**ADDENDUM NO.: 3**

**IFB or RFP NO.:** Bid No. 626

Herman Miller Product

Project: CUNY Central

2. D-01A

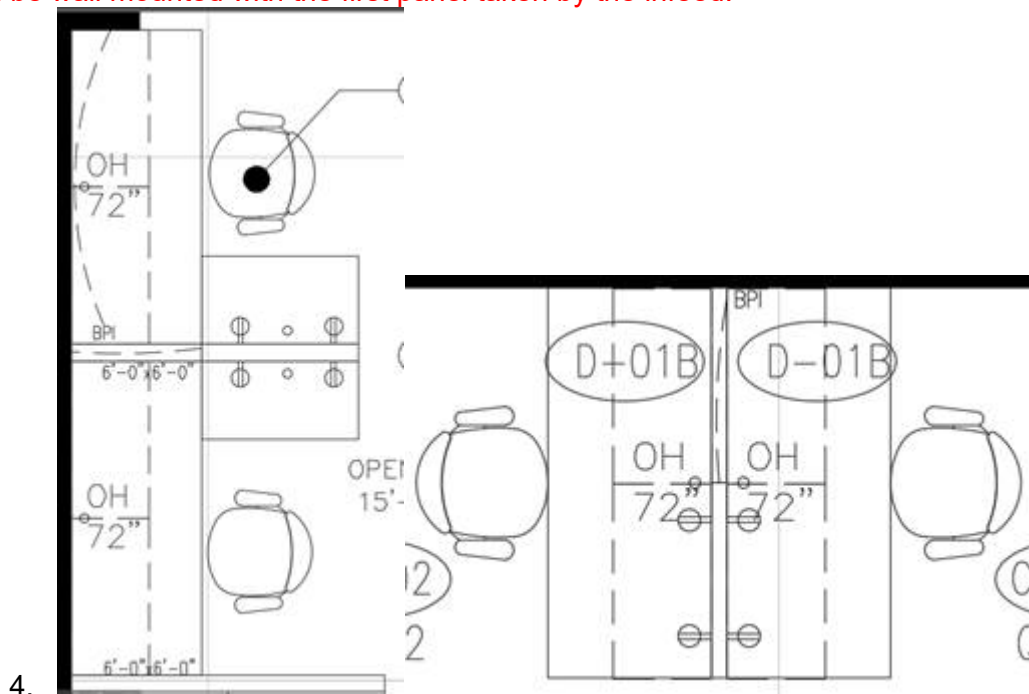
- a. Is the freestanding ped supposed to support the top? Where is this ped located?

No, there should be legs supporting each side with a free standing pedestal underneath. The ped should have a steel top, and will not be attached to the work surface.
